STAFF REPORT

DATE: 5/16/2017

ITEM #: 17

AGENDA ITEM: Rezoning/PUD Amendment – Wildflower at Lake Elmo

Approved PUD Plan

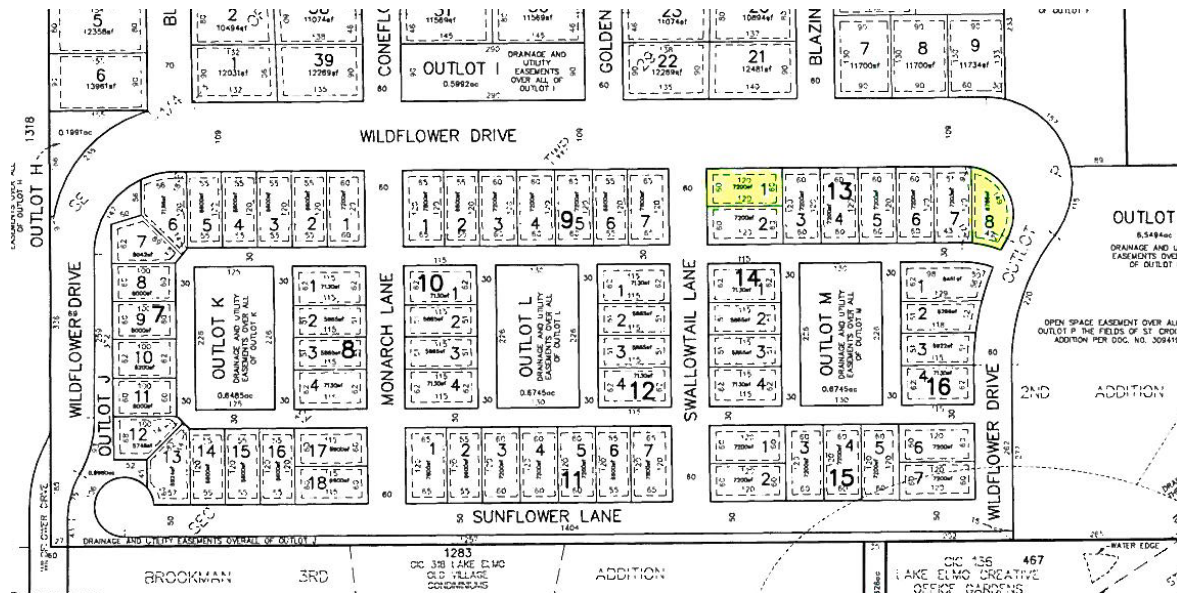
1. Reduce Rear Yard Setback on Lot 18, Block 3 Wildflower at Lake Elmo. The rear yard setbacks for the courtyard lots were codified in the PUD Agreement. It was established that the rear yard setbacks would be 20' for all courtyard lots. The developer is seeking to reduce the rear yard setback for 18, Block 3 from 20 feet down to 10 feet to accommodate a specific client and home plan. The Lots 17 and 18 are 5 ft. shorter than similar lots in the development. By doing so, the developer will be essentially eliminating the small rear yard area on this lot, bringing the garage up to the 10 foot drainage and utility easement. The change will also lessen the distance between the garages on 18 and the home being constructed on Lot 16. The distance between the two structures will be reduced from 28'-7" to 18'-7" if the setback is reduced.

Comments Item #1. Dorschner did not agree with the reduced rear yard setback. The developer knew the lot size and planned a home too large for the site. Dodsens felt the setback requests were inappropriate and the need for the setbacks should have been anticipated and planned for up front. Fields was concerned for the adjacent lot owner who is building a home with the expectation of a 20' rear yard setback.

Preliminary Plat

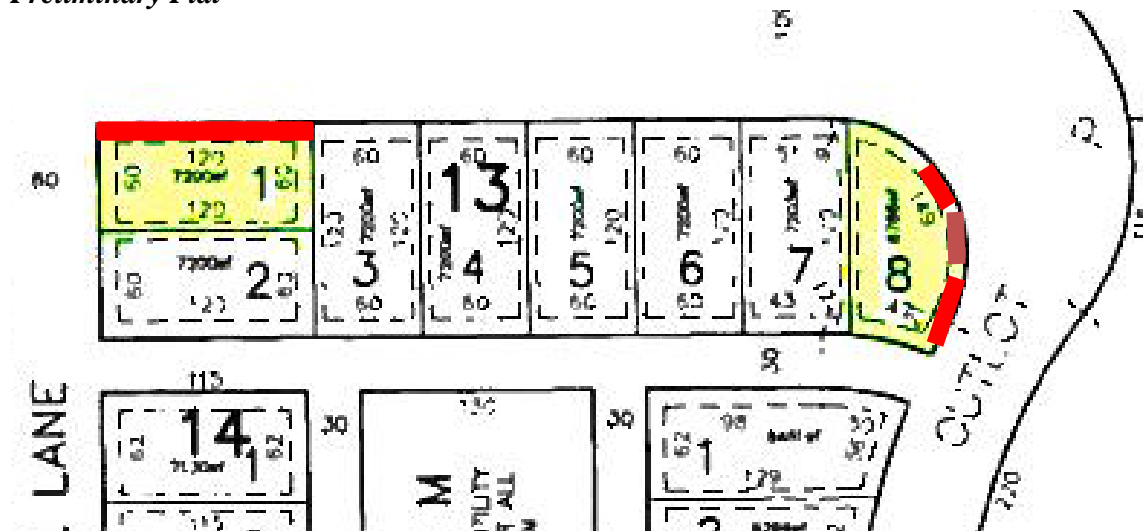
2. Reduce Corner Side Yard Setbacks for Preliminary Plat Lots 1 and 8 Block 13. The developer is requesting that the corner side yard setbacks be reduced from 15 ft. to 10 ft. to provide more flexibility in home design and layout.

Comments Item #2. The Commission was opposed to the request.

Approved PUD Plans

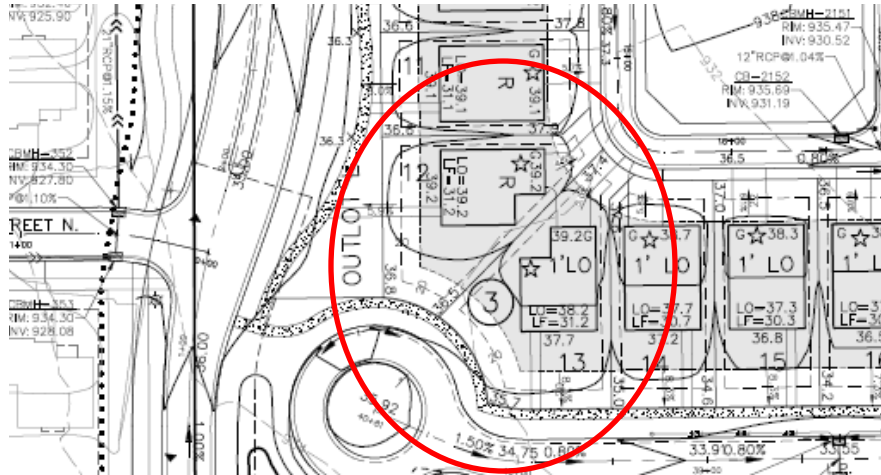
3. To allow the reorientation Lots 12 and 13, Block 3 Wildflower at Lake Elmo 1st Addition to allow driveway access from Sunflower Lane rather than the courtyard. The developer is requesting flexibility to allow re-orientation Lots 12 and 13, Block 3 Wildflower at Lake Elmo 1st Addition to take driveway access from Sunflower Lane rather than from the courtyard as originally planned. The proposal is a deviation from the concept plan of having garage doors and driveways accessed from the rear and front entrances and sidewalks facing the perimeter streets. Another issue to consider is the curbing in the Sunflower Lane cul-de-sac is a B6-12 curb type,

and is not surmountable. The existing curbing in the cul-de-sac would need to be replaced with a surmountable curb to accommodate a driveway and would need to be replaced prior to the installation of the final lift of asphalt. There may also be public utility or joint trench conflicts associated with this change that would need to be evaluated if allowed. If the Council approves this change, Staff recommends that a condition be added that prior to approval such that the individual building permits for each lot will need to be reviewed by the City Engineer for potential conflicts before the driveway will be allowed by the City.

Comments Item #3. Commissioners Dodsens and Dorschner felt the driveway requests were reasonable. Commissioner Dodsens proposed the following finding related to item #3 the Commission finds the preliminary plat design for lots 12 and 13 are problematic in the courtyard and are too close together.

Approved PUD Plans

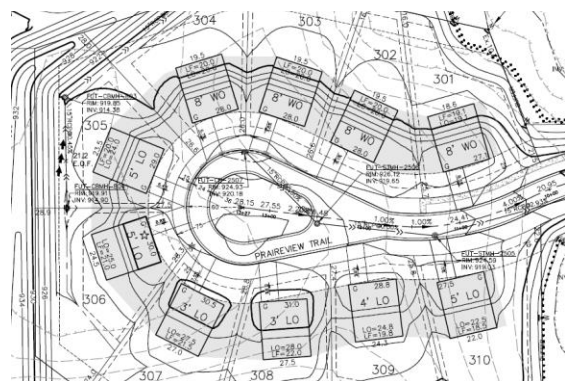
The developer would like to reduce the House Side Yard Setback to 10 feet and the Garage Side Yard Setback to 5 feet consistent with the LDR Zoning District. This change would result in a more urban look to the Ridge and Conservancy Lots and a loss of some of the openness. This will change the look of the PUD development and is a general deviation from the Concept PUD Plan.

7. Reducing the side yard setbacks for Ridge and Conservancy lots is a deviation from the concept plan. It also does not provide any additional benefits to the City and may cause impacts to the development's stormwater management.

**WILDFLOWER AT LAKE ELMO
(Garden Villa Homes - Total 67)
PUD AMENDMENTS:**

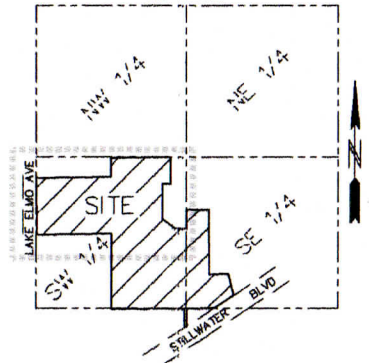
- CORNER LOTS WITH 15' SIDE YD SETBACK REDUCED TO 10'  to Lots
- PARALLEL LOTS:
CORNER LOTS THAT AT CERTAIN LOCATIONS ALLOW FOR
FRONT FACING HOMES ON THE LONG SIDE OF LOT:
5 LOTS REQUIRED 
- DRIVEWAY LOCATIONS:
OPTIONAL LOCATIONS SHOWN FOR STREETScape VARIETY 
- REDUCE REAR SETBACKS FROM 20' to 10' 
- ~~ALLOW~~
